Rezoning Transportation Analysis

Petition Number: 2020-014

From: Felix Obregon, PE
fobregon@charlottenc.gov
704-432-5729

Reviewer: Eric Lemieux, PE
eric.lemieux@charlottenc.gov
704-336-2683

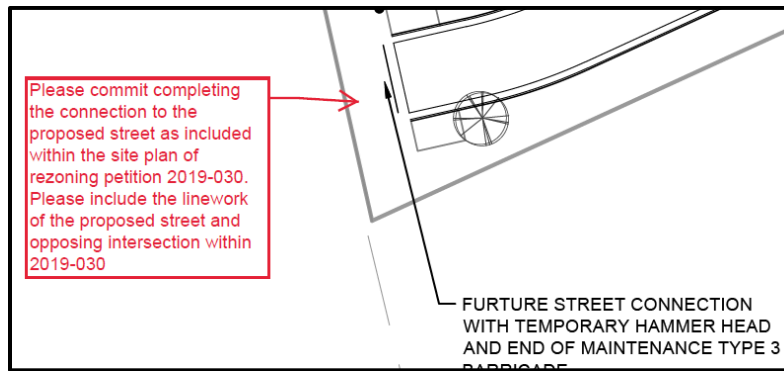
~~8. The petitioner should revise the site plan and conditional note(s) to commit to construct a signalized pedestrian crossing to the Lake Wylie Elementary school.~~
